WALL CHECK

B2508907

4401 Garrison St, N.W.
Lot 80 or 1501

Zoning review 1

Wall Report for.....SQUARE 1581.....LOT 80.....

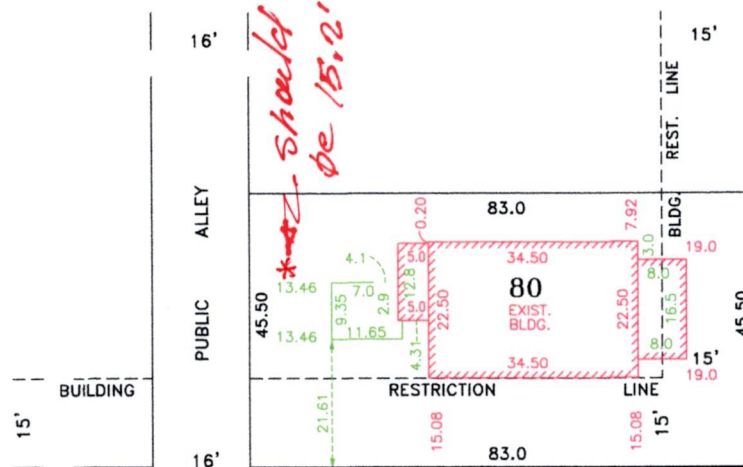
Applicant received relief from the BZA for a 15.2' rear setback, and the built structure provides a 13.46' rear setback which increases,

Wall check was
REJECTED by Zoning
